REVIEWER COMMENTS

This manuscript focuses on addressing the temperature-sensitivity issues inherent in dielectric-based soil moisture (SM) sensors, which often lead to spurious daytime peaks in diurnal cycles. The authors propose an empirical correction method based on Fast Fourier Transform (FFT) by leveraging the physically consistent diurnal patterns from land surface model (LSM) reanalysis datasets. The performance of the adjusted SM data was validated against reference sensors and further evaluated through land-atmosphere coupling analysis. Overall, the study provides a practical and innovative solution to a long-standing problem in the hydrological community. The topic fits well within the scope of the journal. However, considering there are some critical methodological issues and data inconsistencies that need to be clarified, I recommend a major revision.

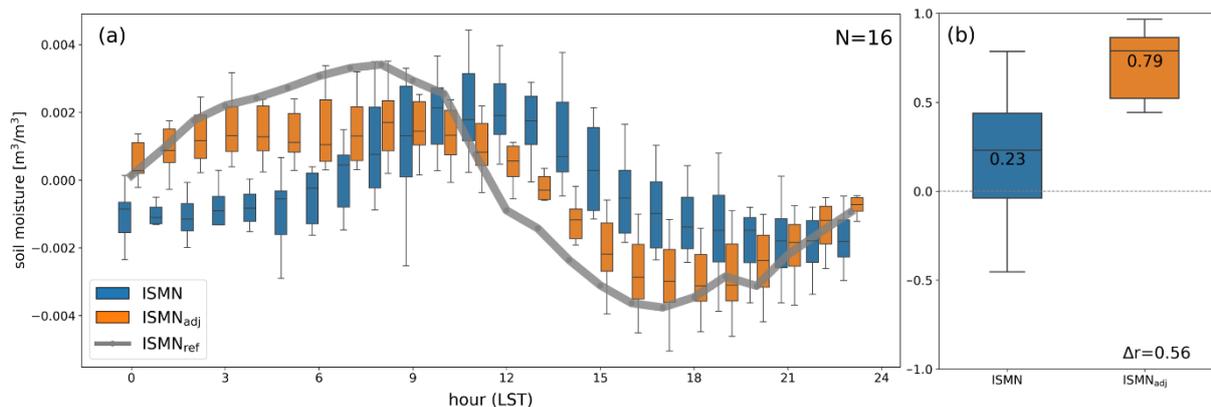
3. Regarding the precipitation filtering (Section 3.1), I have concerns about the consistency and physical basis of the thresholds used. The authors used a +1.5 standard deviation (SD) threshold for in-situ data but a 0.1 mm/day threshold for LSMs. (1) Since SM response to rain is highly dependent on soil texture and antecedent moisture, can a universal +1.5 SD threshold reliably identify rainy days across all global ISMN sites? (2) Why was the 'previous day' (L206) excluded along with the rainy day, rather than the following day, which is typically affected by post-rainfall drainage? (3) The use of different filtering methods for models and observations may lead to mismatched samples in the FFT adjustment. The authors should justify these choices.

→ *Regarding the precipitation masking based on a soil moisture tendency threshold, as noted by the reviewer, soil moisture responses to precipitation vary with observation sites; thus, employing a single global threshold necessitates certain simplifications. To evaluate the practical efficacy of this approach, we conducted a sensitivity analysis using all collocated ISMN SM-precipitation station pairs (n=240). This analysis compared SM-based masking criteria against collocated precipitation observations across different thresholds (1.5, 1.0, and 0.5 SD).*

The masking performance was evaluated based on two key metrics: (1) the number of overlapping days identified as rainfall-affected by both precipitation observations and the SM SD-based criterion, and (2) the proportion of observed rainfall days not detected by the SD-based threshold (the omission rate). The results (below contingency tables) indicate that the initial 1.5 SD threshold primarily captures only intense and abrupt SM spikes, thereby missing a substantial number of moderate precipitation events. In contrast, a lower threshold of 0.5 SD yields a more balanced identification, enhancing the agreement with observed rainfall days while significantly reducing the fraction of missed events. Based on these results, we revised the threshold from 1.5 SD to 0.5 SD in the updated manuscript (Lines 208-214 and Fig. S2).

"To exclude rainy days at observation sites, hourly SM measurements are aggregated into a daily resolution to calculate the day-to-day SM tendency. When this tendency exceeds a threshold of +0.5 standard deviations (SD), determined over the entire analysis period, both

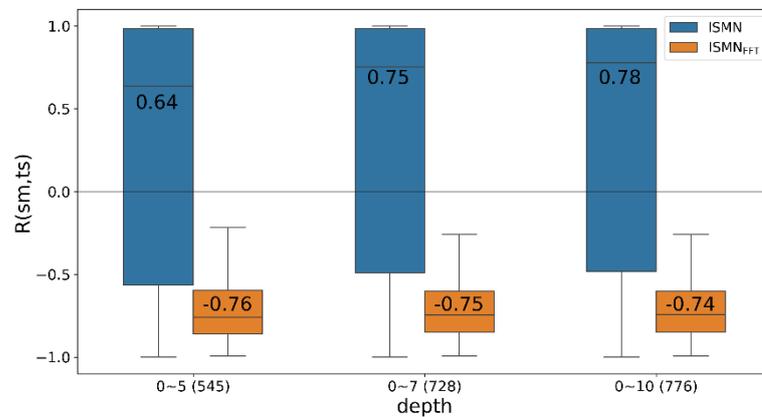
5. There is a clear discrepancy between the measurement depths of the LSMs (0–7 cm for ERA5-Land, 0–5 cm for MERRA-2) and the in-situ sensors (top 10 cm). Soil moisture and temperature in the top few centimeters are often Using the diurnal power of a 0–5 cm layer to correct a 10 cm layer might introduce vertical representativeness errors. This point needs more rigorous justification.

→ *We acknowledge the reviewer's concern regarding the vertical representativeness mismatch between the LSM soil moisture layers (0–7 cm for ERA5-Land and 0–5 cm for MERRA-2) and the in-situ measurements representing the top 10 cm. The use of the 0–10 cm in-situ layer was initially motivated by consistency with widely adopted near-surface soil moisture definitions in reanalysis and land surface models (e.g., a top layer on the order of 0–10 cm).*

To assess the potential impact of this depth mismatch, we conducted additional sensitivity tests by restricting the analysis to in-situ sensors whose measurement depths most closely match the corresponding model layers. The resulting diurnal power and correlation characteristics showed no apparent differences compared to those obtained using the full 0–10 cm in-situ dataset.

These results indicate that, despite small differences in nominal layer thickness among datasets, the diurnal signal targeted in this study is sufficiently robust within the near-surface soil layer.

Therefore, we consider the use of the 0–10 cm in-situ observations to be appropriate for the purposes of diurnal-cycle-based adjustment. Additional explanation has been added to the manuscript, and the corresponding figure has been included in the Supplementary Material (Lines 311–317).

“Although the nominal layer depths vary between ERA5-Land (0–7 cm), MERRA-2 (0–5 cm), and in-situ measurements (top 10 cm), all datasets characterize near-surface soil moisture, where diurnal variability is most pronounced. To evaluate the potential impact of this vertical discrepancy, additional sensitivity analyses were conducted by grouping stations according to their specific measurement depths (0–5, 0–7, and 0–10 cm). The resulting correlation characteristics remained highly consistent across all depth groups (Fig. S5), suggesting that the vertical representativeness mismatch has a negligible influence on the diurnal signals analyzed in this study.”

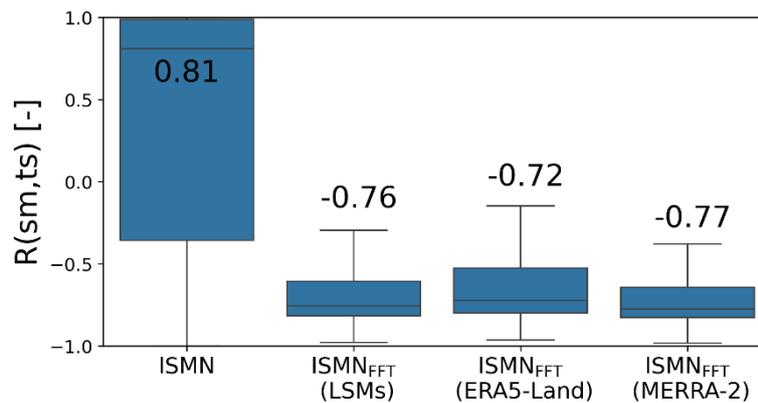
6. The correction relies on the assumption that sensors are insensitive to temperature during 20:00–06:00 LST. However, in many regions, soil temperature can remain high or continue to fluctuate significantly during the early night. Does this "baseline" assumption hold across all climate zones?

We appreciate the reviewer’s concern regarding potential soil temperature fluctuations during the early nighttime hours. To minimize the potential influence of such fluctuations, we revised the definition of the nighttime baseline period from 20:00–06:00 LST to a more conservative window of 22:00–04:00 LST. This narrower interval more closely represents the period when surface temperature variability is relatively stable and temperature-driven sensor artifacts are minimized. The manuscript has been revised accordingly in Lines 247–248 and 387–389.

“Assuming SM measurements to be relatively insensitive to temperature during the nighttime hours (22:00–04:00 LST) due to the absence of solar radiation, we further correct the mean of diurnal anomaly for each day.”

“Additionally, a diurnal mean correction (22:00–04:00 LST) is incorporated, assuming that the sensor temperature sensitivity is limited during nighttime periods when temperature-induced errors are minimal, thereby serving as a baseline for the correction.”

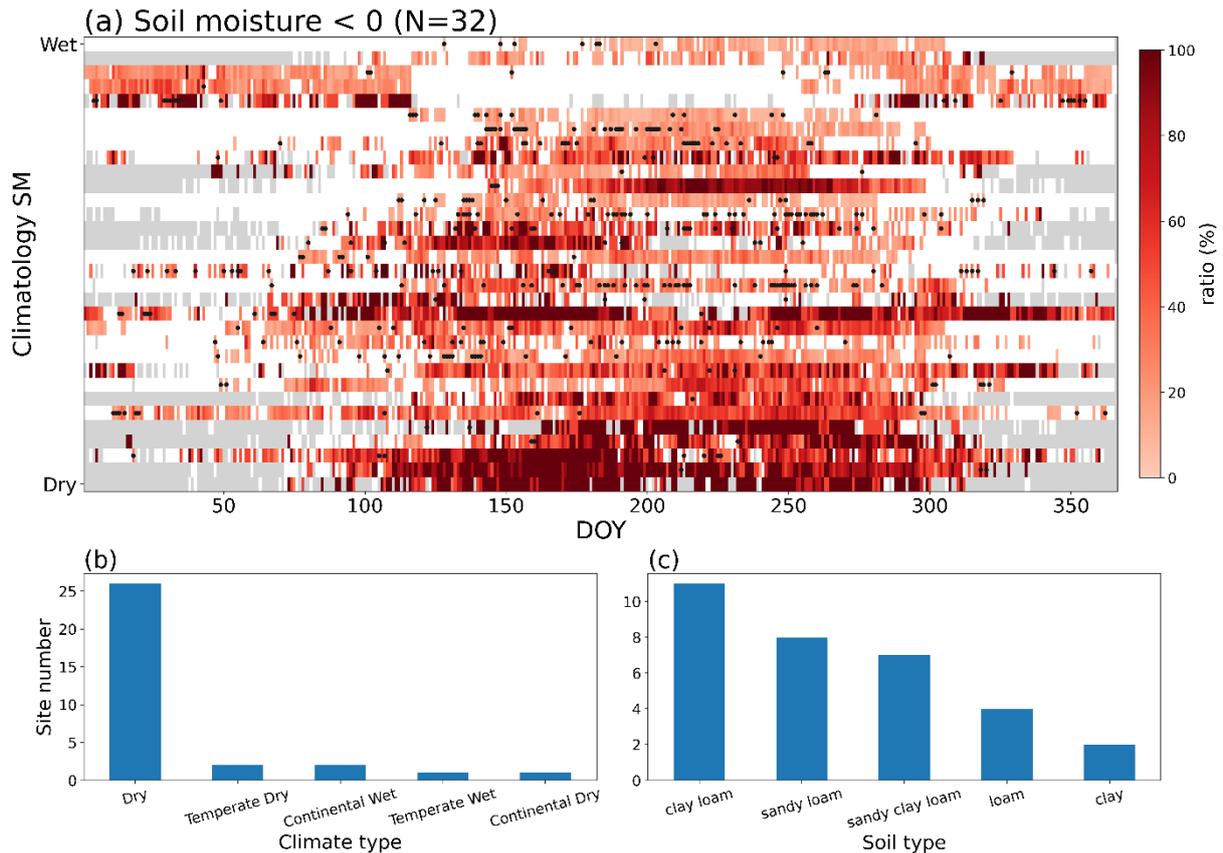
8. The application of standard normal deviate scaling (SNDS) to avoid negative values is an additional empirical step. I wonder if this scaling process significantly alters the original variance or the physical meaning of the diurnal amplitude.

→ We appreciate the reviewer’s comment regarding the use of SNDS. The occurrence of negative soil moisture values after phase adjustment was examined in detail. Among 745 stations, only 32 exhibited more than 100 hours of negative values, indicating such cases are relatively rare. These stations are predominantly located in dry regions with loam-type soil, where strong daytime heating can induce large diurnal amplitudes in soil moisture. During the phase-adjustment (1st) step, inversion of the diurnal cycle under these conditions can occasionally produce unrealistically low reconstructed values.

Importantly, soil moisture values below zero are physically implausible and therefore require correction. The SNDS procedure is applied only to these limited cases to prevent non-physical values while preserving the daily mean soil moisture. Because the adjustment affects only a small subset of stations and observations, and does not modify the daily mean, its impact on the overall variance and the physical interpretation of the diurnal amplitude is expected to be minimal. The corresponding details are explained in Lines 255-260 and Fig. S4.

“To evaluate the extent of this supplementary SNDS adjustment, we quantified the frequency of negative values across all stations. Only 32 stations exhibited more than 100 cumulative

hours of negative SM following the phase-adjustment step. These stations are primarily located in arid regions with loamy soils (Fig. S4), where strong daytime heating induces disproportionately large diurnal amplitudes. Since SNDS is restricted to these infrequent occurrences, its impact on the overall variance structure and the physical interpretation of the diurnal signal remains negligible.”

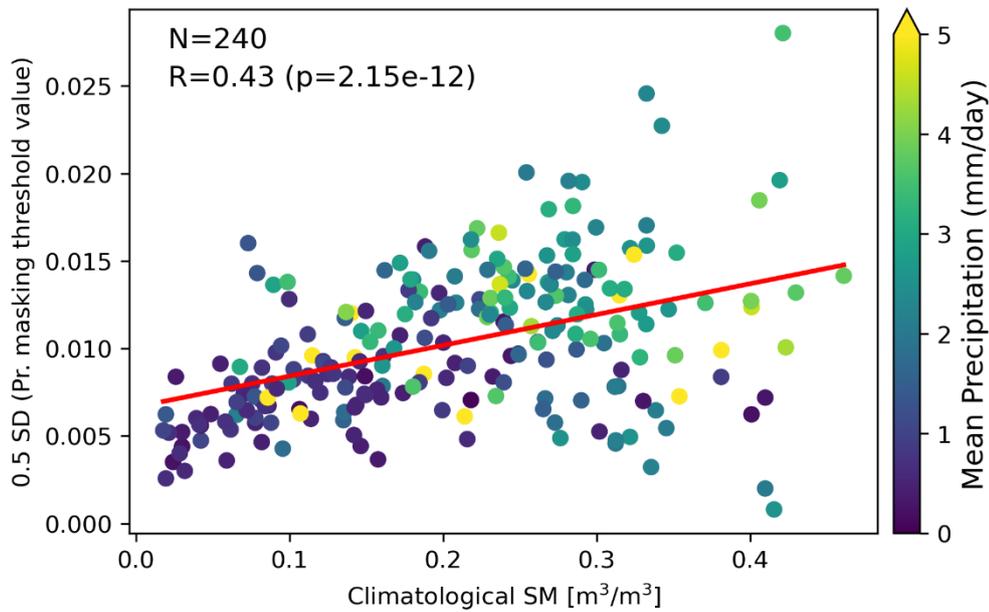
1) L205-207: The +1.5 standard deviation threshold for excluding rainy days seems somewhat arbitrary. Is this value robust for both humid and arid regions?

➔ *We evaluated the potential climate dependence of the +0.5 SD threshold by examining its relationship with climatological mean SM across stations with precipitation observation data. The regression pattern shows that climatological SM generally increases from approximately 0 to 0.3 and exhibits a slight decrease in the 0.3–0.5 range, with the overall SM variability bounded within approximately 0.5. In comparison, the absolute magnitude of the +0.5 SD threshold is very small (approximately 0–0.02), which is much smaller than the typical range of climatological SM variation. Therefore, the threshold is applied at a scale that is negligible relative to long-term SM climatology, supporting the conclusion that the criterion is not sensitive to arid–humid climate separation. This explanation has been added in Lines 213-214 and Fig. S3.*

“notably, these threshold values vary according to local climatology, with higher thresholds assigned to wetter regions (Fig. S3).”
